Access Compliance Report

Public Rights-of-Way

(Curb Ramps)

Intersection ID: 8171	Main Street: OLD_CONCORD_RD	Cross Street: DONNA_DR	Location: NE
ADA ID: A2767BC7A5E4	Ramp Type: Perp	Initial Pass/Fail: Fail	Overall Compliance: No
Severity Score: 1.25			
Codes/Mitigation Info/Possible Solution		Field Measurements/Component Compliance

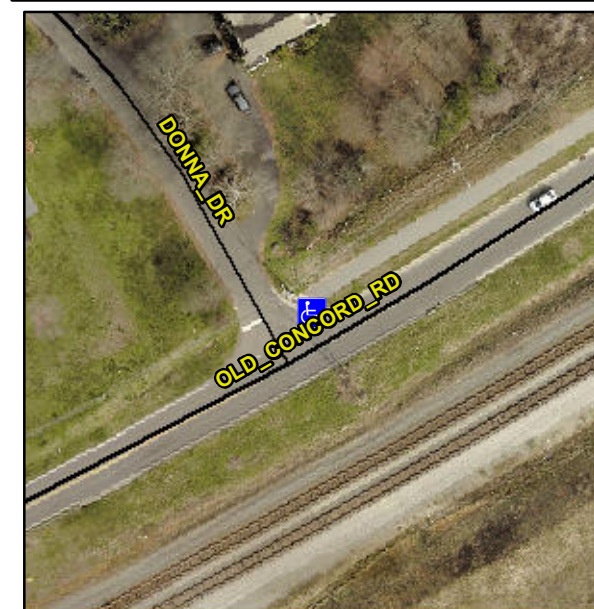
Not Found, R304.5.3

Compliance	Description	Data	Compliance	Description	Data
N/A	Ramp Length (in)	72.0	Yes	Ramp Slope (%)	7.7
Yes	Ramp Width (in)	76.0	No	Ramp XSlope (%)	4.1
N/A	Flare Type LT	N/A	N/A	Flare Type RT	N/A
N/A	Flare Slope LT (%)	N/A	N/A	Flare Slope RT (%)	N/A
N/A	Flare Traversable LT?	N/A	N/A	Flare Traversable RT?	N/A
N/A	Landing Length (in)	N/A	N/A	DWS Provided?	N/A
N/A	Landing Width (in)	N/A	N/A	DWS Contrast?	N/A
N/A	Landing Slope (%)	N/A	N/A	DWS Length (in)	N/A
N/A	Landing X Slope (%)	N/A	N/A	DWS Full Width?	N/A
N/A	Landing Curb? (Y/N)	N/A	N/A	DWS Offset (in)	N/A
N/A	Shared Landing?	N/A			
N/A	Gutter Ponding?	N/A	N/A	Gutter Slope (%)	N/A
N/A	Gutter Lip Ht (in)	N/A	N/A	Gutter X Slope (%)	N/A
N/A	Painted X Walk1?	No	N/A	Painted X Walk2?	N/A
	X Walk 1 Direction	To W		X Walk 2 Direction	N/A
N/A	X Walk 1 Width (in)	N/A	N/A	X Walk 2 Width (in)	N/A
	X Walk 1 Slope (%)	2.9		X Walk 2 Slope (%)	N/A
	X Walk 1 X Slope (%)	2.4		X Walk 2 X Slope (%)	N/A

Remove & Replace Entire Ramp.
